RE: Application of Orange County-Poughkeepsie Limited Partnership d/b/a Verizon
Wireless -110 Howland Avenue

Please accept this letter as Verizon Wireless' response to the comments provided in the John Clarke Planning and Design January 11, 2019 letter in connection with the above referenced application. For ease of reference, Mr. Clarke's comments have been provided below in their entirety followed by our responses.

OVERALL SITE PLAN

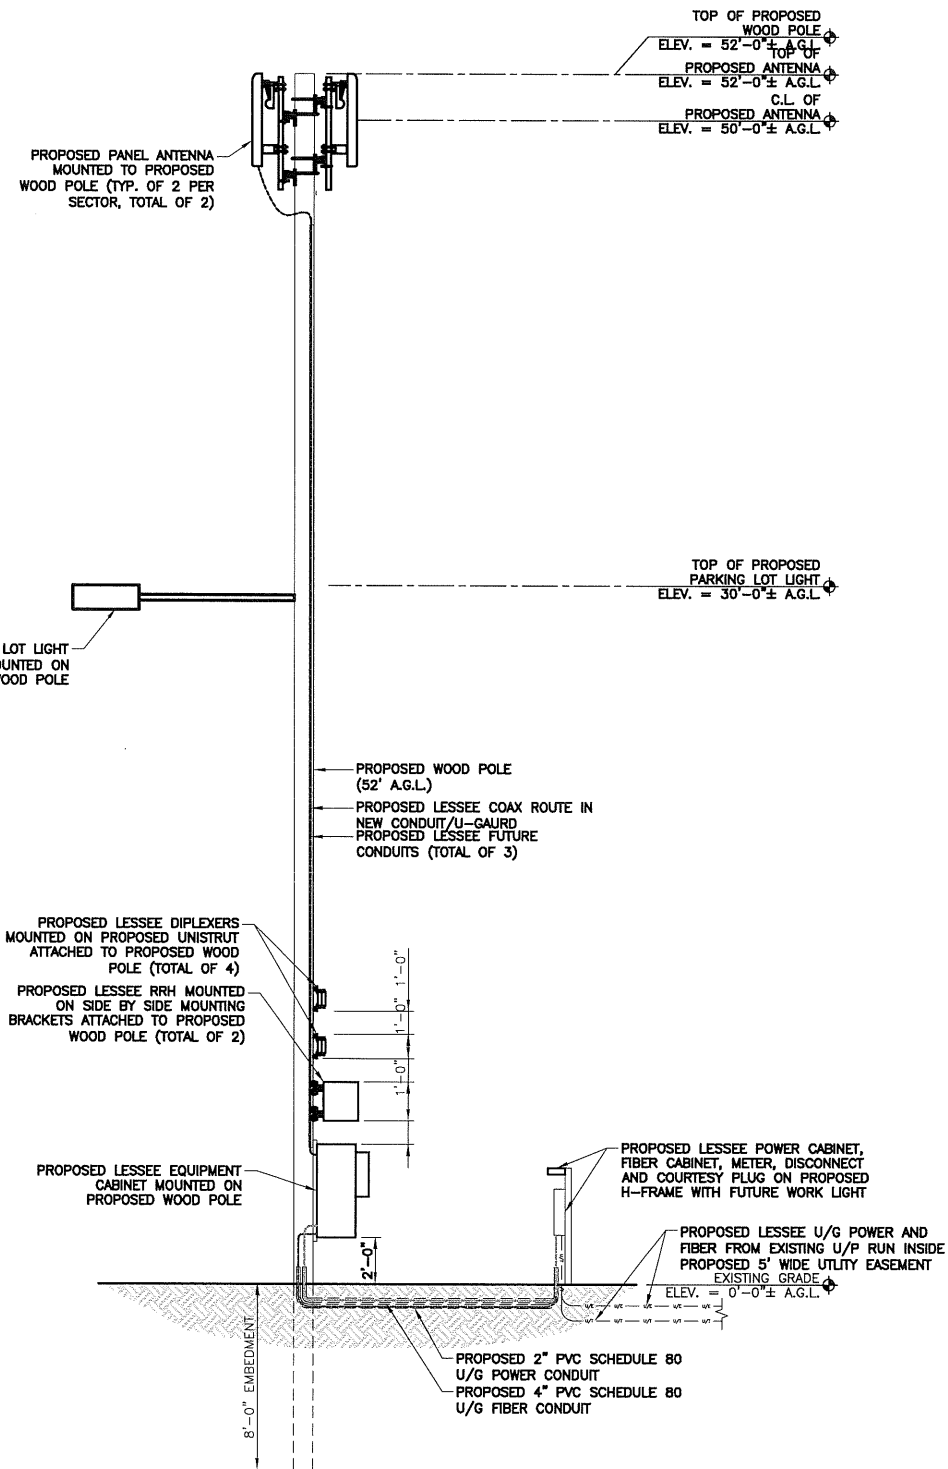
7. The Site Plan should show the setback distances from the tower to the residential building on the site and to the surrounding property lines, meeting the setback requirements in 223-24.5 E.

Response: The enclosed plans have been revised to include the requested information.

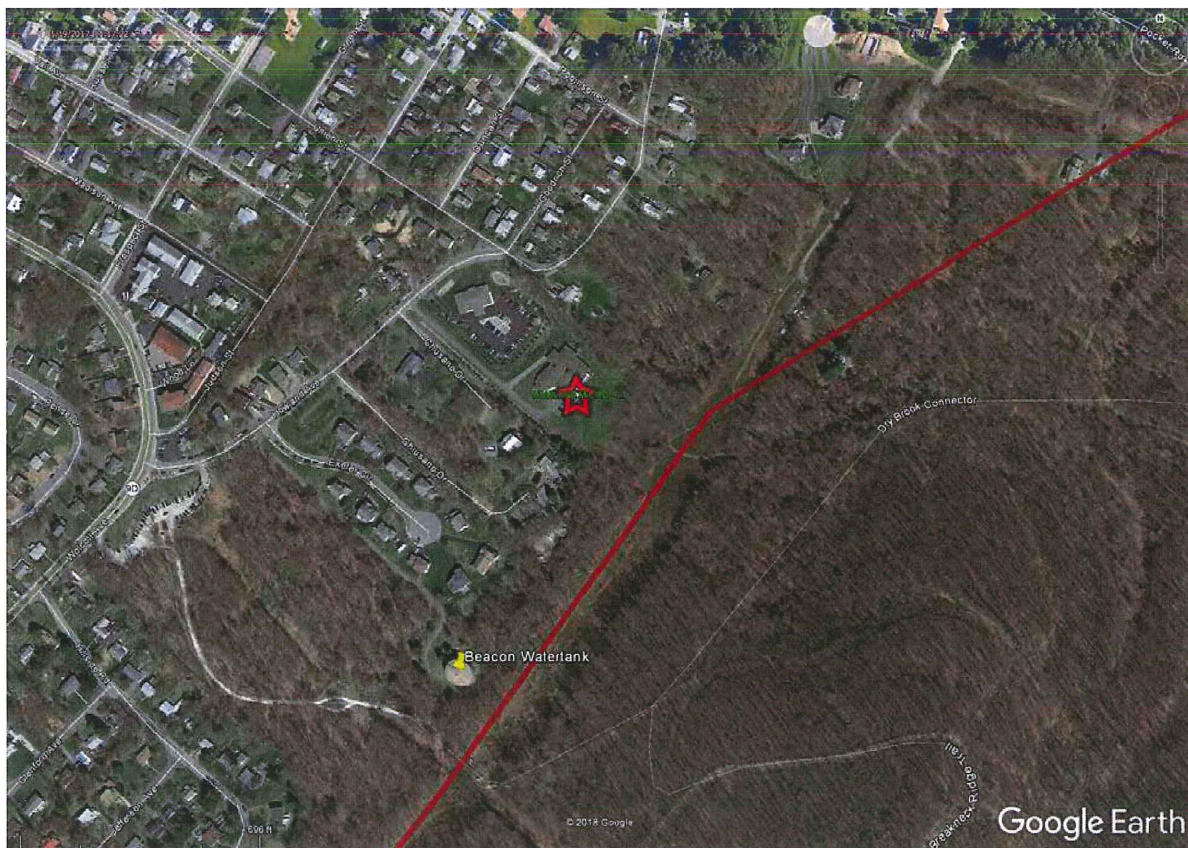
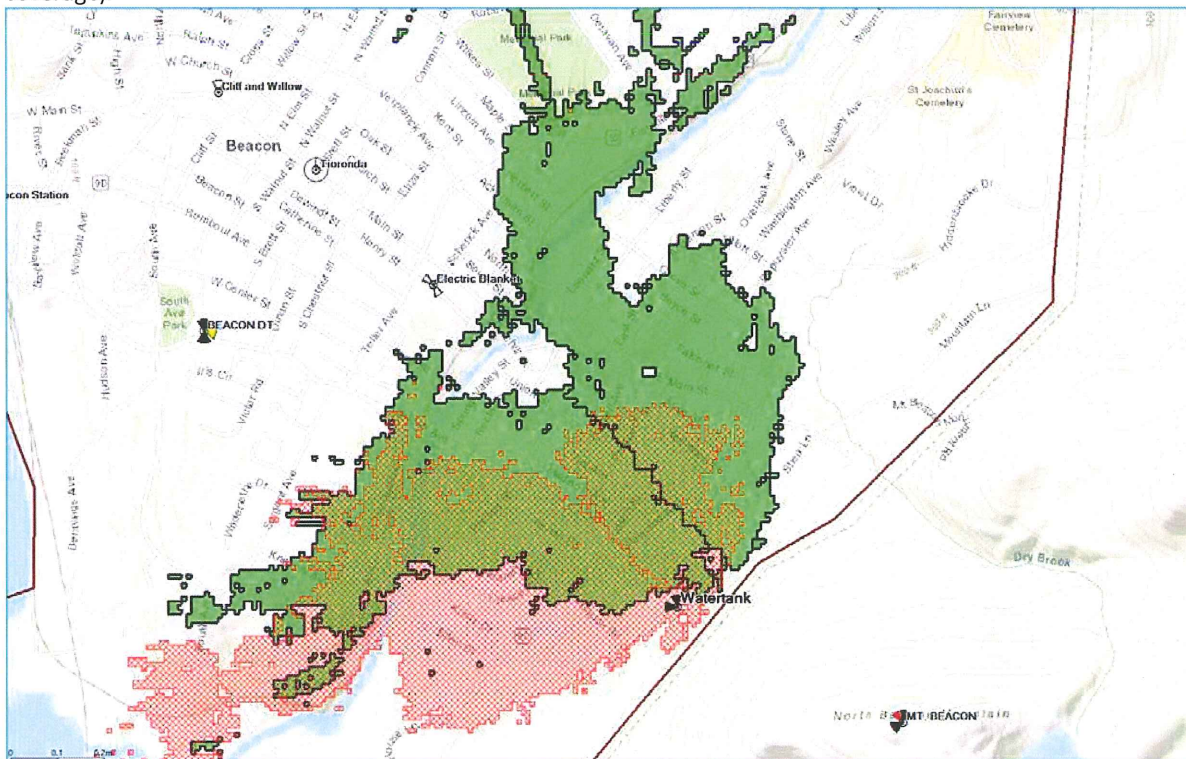
A question was posed as to whether or not Verizon may be able to move the proposed installation to an alternate water tank location off Howland Ave near the Breakneck Ridge Trail.

1. Too low of position relative to its local obstructions. The water tank location compared to the proposed Howland location suffers from unacceptable signal degradation to the north due to far field (view) blocked by dense localized clutter. The dominant footprint that is necessary to offload the existing sites is not possible from this location due to being blocked by terrain and foliage. Having a clear line of sight (LOS) to area objectives is critical when designing new micro sites at cellular frequencies.
2. Poor positioning relative to some area objectives as well as other sites. The water tank is approximately 800' south of the identified search ring. This distance combined with the above mentioned obstructions further limit this locations ability to serve the necessary objectives and provide the necessary capacity offload detailed in the RF Justification.

The image below helps visualize the difference in coverage between the proposed Howland site (Green coverage footprint) and the Beacon Water Tank (Red hashed coverage footprint). Small cell facilities are designed to have smaller coverage footprints and therefore even a slight relocation of the site can significantly alter site performance. As can be seen in the plot below...the water tank site would not serve the intended area (~50% less coverage).
